# Site Accessibility Evaluation

### Department of Human Services

**5850 Championship View  
Colorado Springs, CO  
80922**

**Accessibility Evaluation**

### Finding: 1

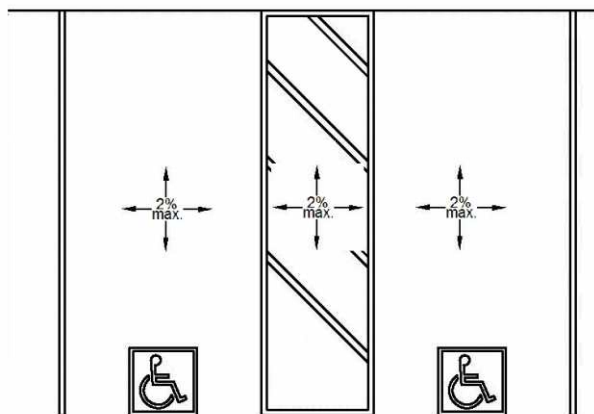
The accessible parking stall's access aisle contains a built up curb ramp which results in significant slopes greater than 2 percent.

Built up curb ramp protrudes into parking access aisle with a running slope of 12.3%

Remove protruding ramp and design/construct parallel curb ramp into existing sidewalk not to exceed 8.33% running slope, a landing on top a minimum of 48 inches with a cross and running slope not to exceed 2%.

CORRECTED

### **Finding: 2**

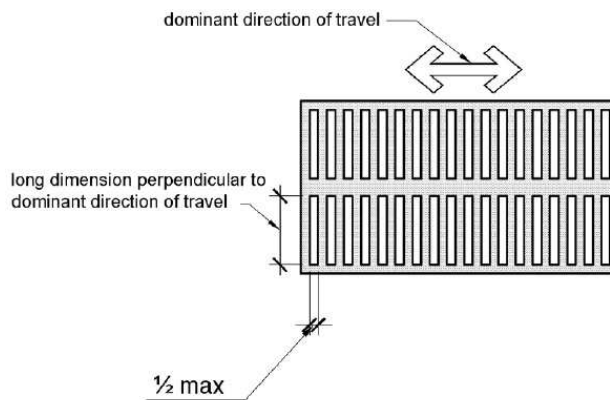
The concrete expansion joint is spaced greater than 1/2 inch.

Opening on top of  
protruding curb ramp  
2 inches wide

Remove protruding built up curb ramp and reconfigure sidewalk to incorporate a parallel curb ramp.

CORRECTED

### Finding: 3

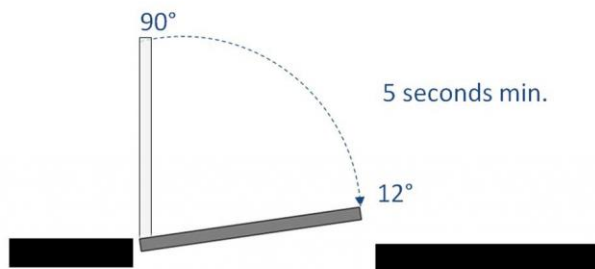
The door is equipped with a door closer and returns to a closed position too quickly.

2.8 seconds to a position of 12 degrees from the latch

Adjust door opener to a minimum of 5 seconds from an open position to a position of 12 degrees from the latch.

CORRECTED
